REVISED
PLAN COMMISSION
MEETING NOTICE AND AGENDA
Thursday, March 18, 2021
7:00 PM
VIRTUAL ONLY

Discussion and Action Regarding a Recommendation to the Common Council for a Conditional Use Permit and Site and Building Plans for Zeilhofer Properties, LLC for Property Located at N4 W22540 Bluemound Road for the Purpose of Constructing a New Freestanding Two-Story Storage Building (PWC 0963997)

Date: February 15, 2021 (3/8/21 - A/E Comments in RED)
To: Mark Wershay, Zimmerman Architectural Studios, Inc.
From: Nick Fuchs, Planner & Community Development Director
RE: Zeilhofer storage building Conditional Use and Site & Building Plan Review

A0.1

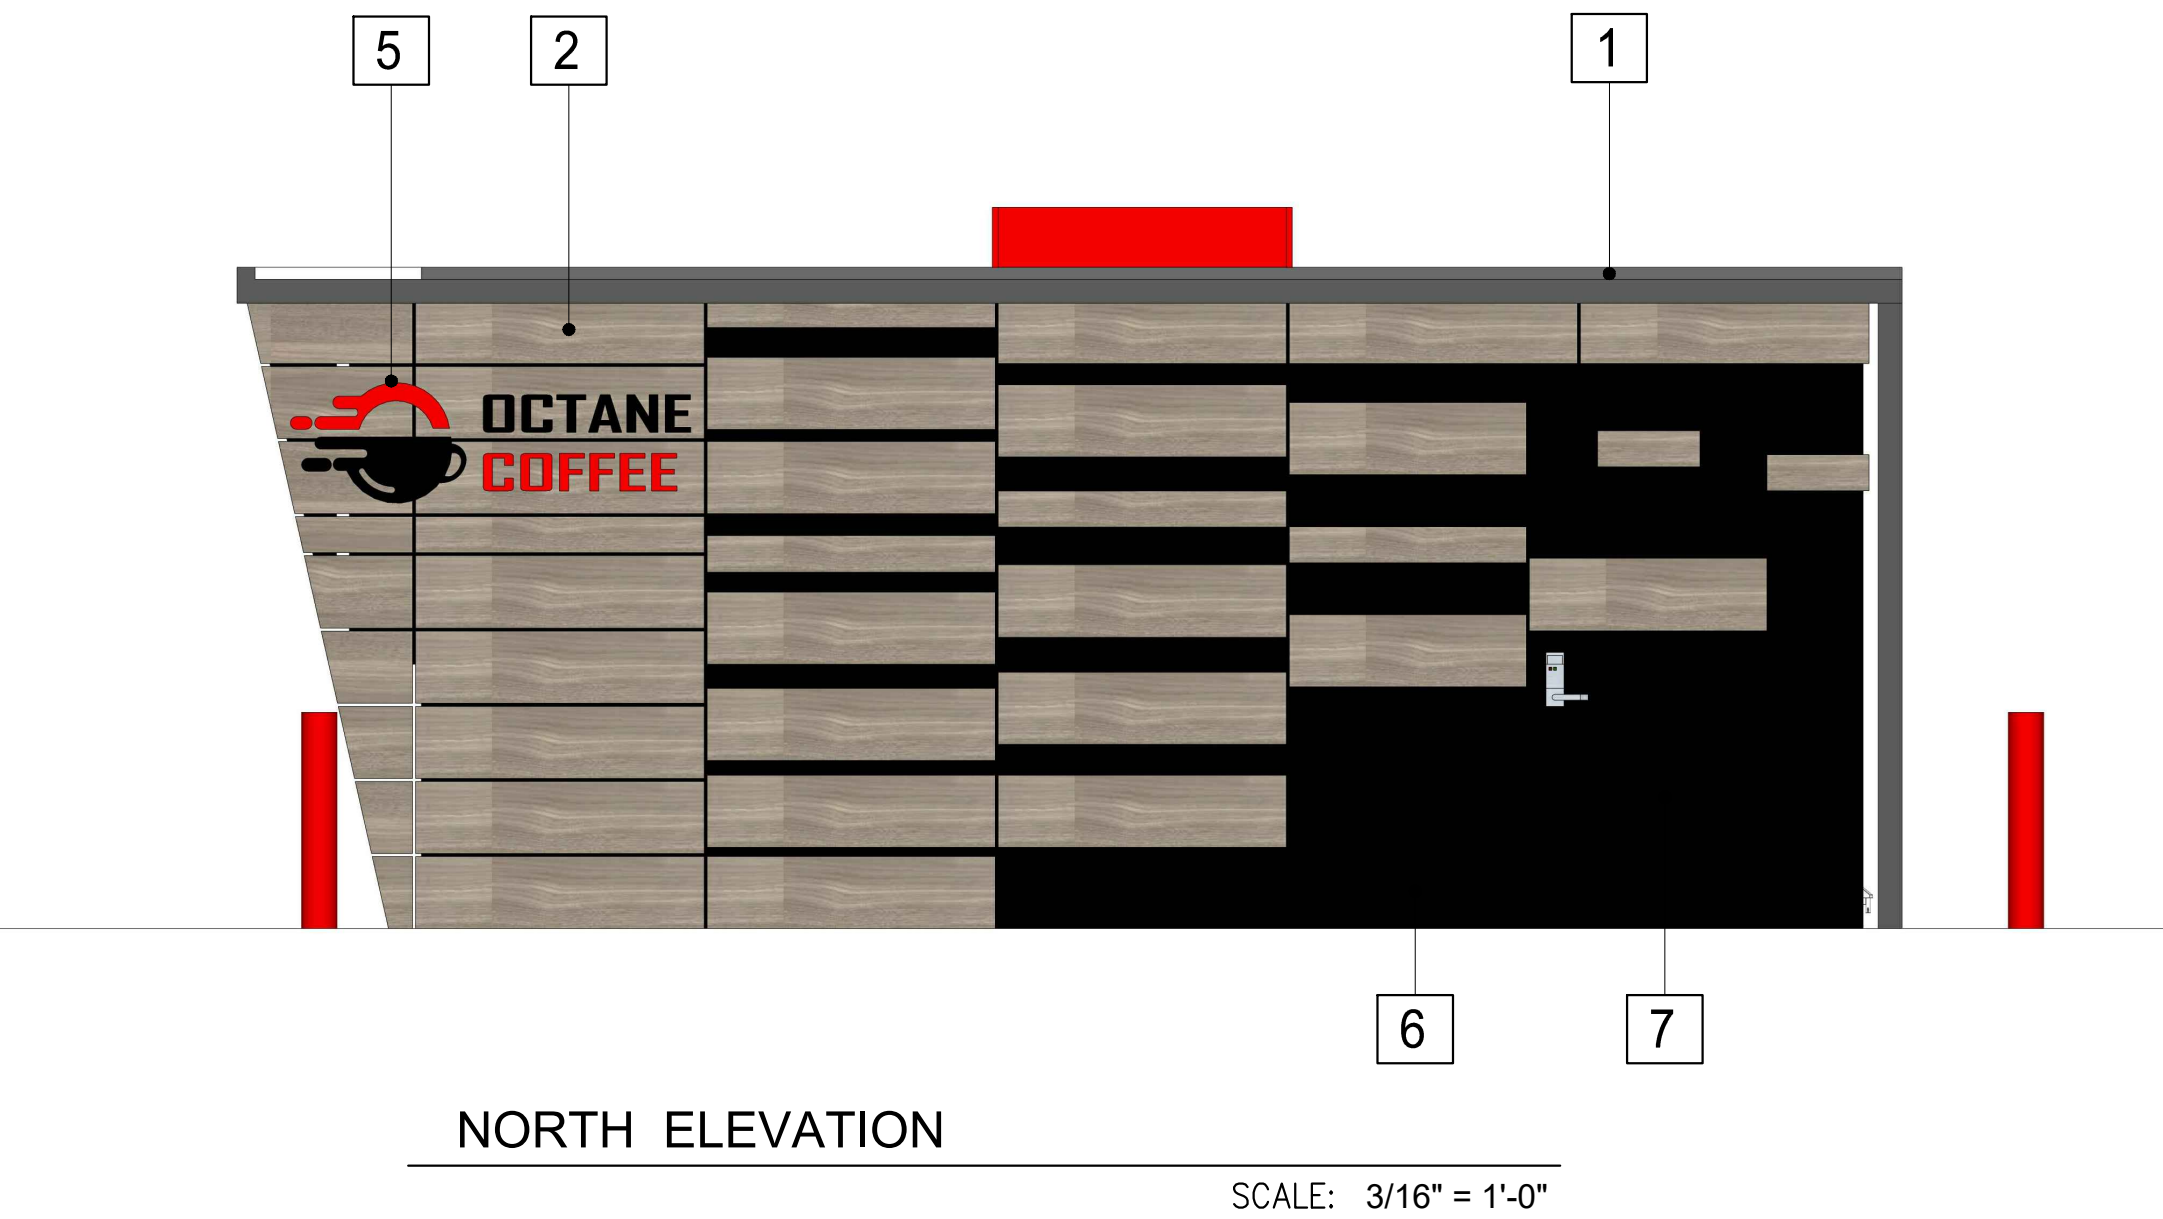
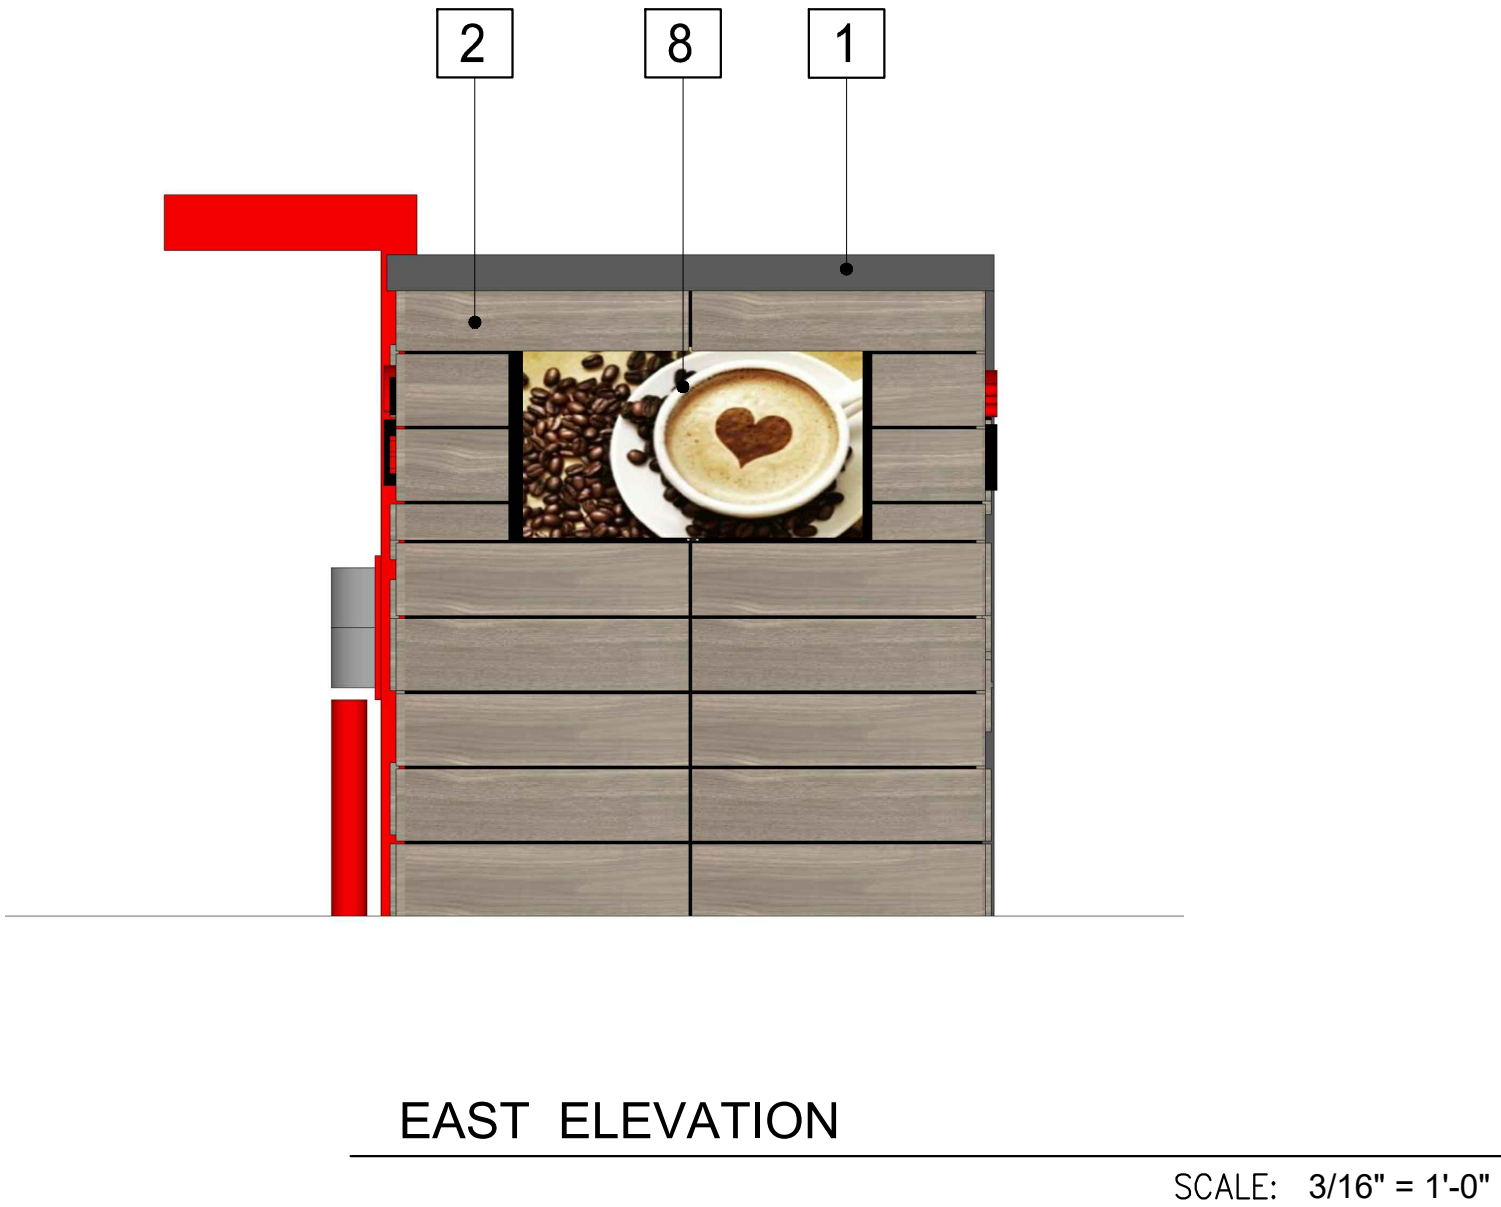
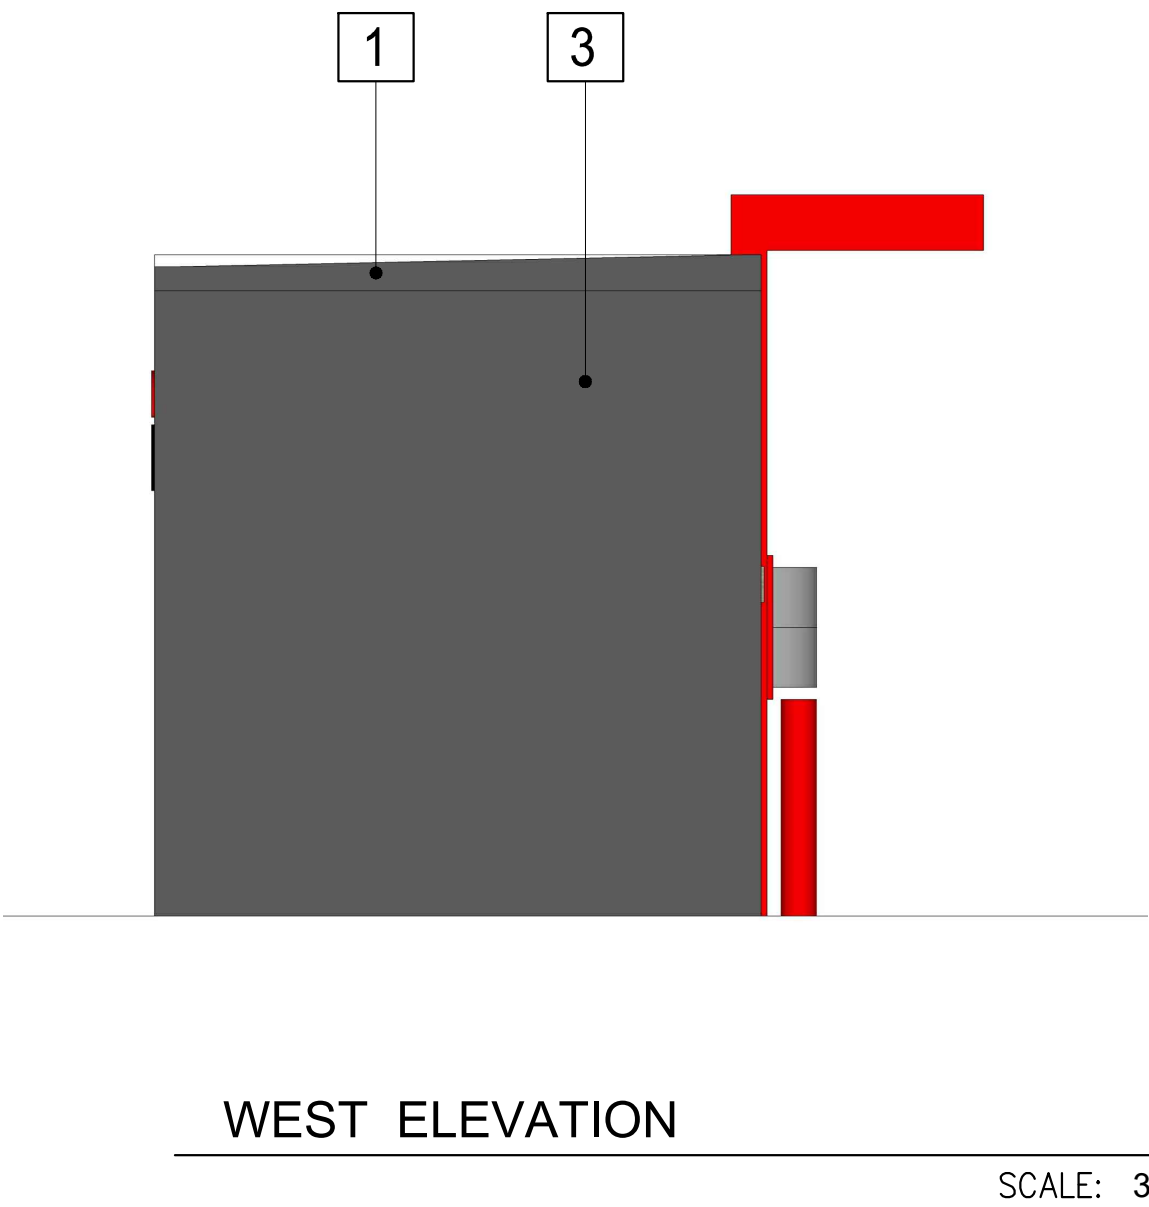
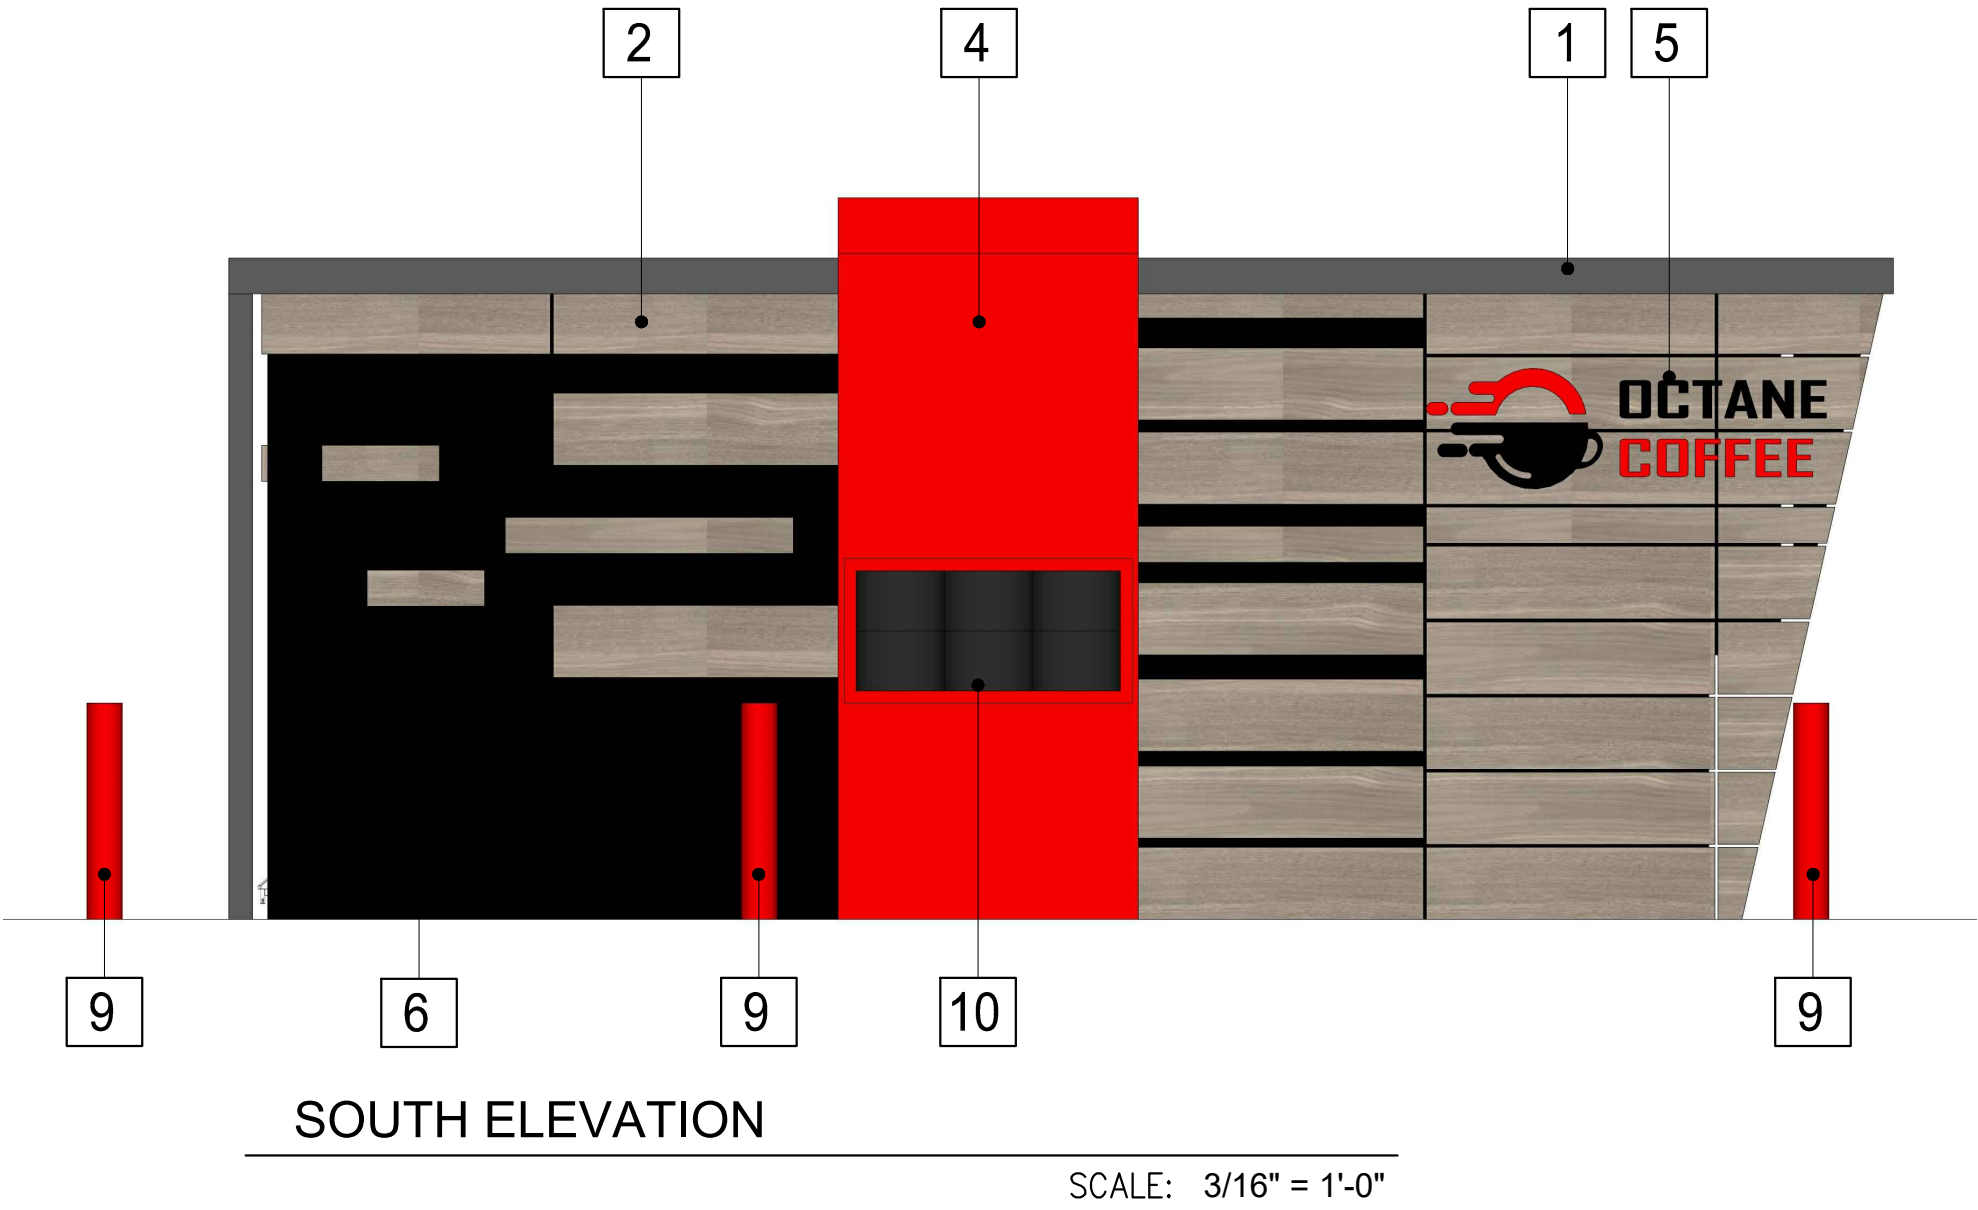
- 7. It is recommended that an exit lane be dedicated for vehicles that decide to exit the drive through.**
 - a. We will add a 'bail out' lane into the current striping plan that will allow a car to exit the drive-thru if necessary.

- 8. It is recommended that landscaping or planters be installed around the building.**
 - a. Understood, we can add some planters around the building.
- 9. Please be aware that the City generally does not allow metal as a primary building material.**
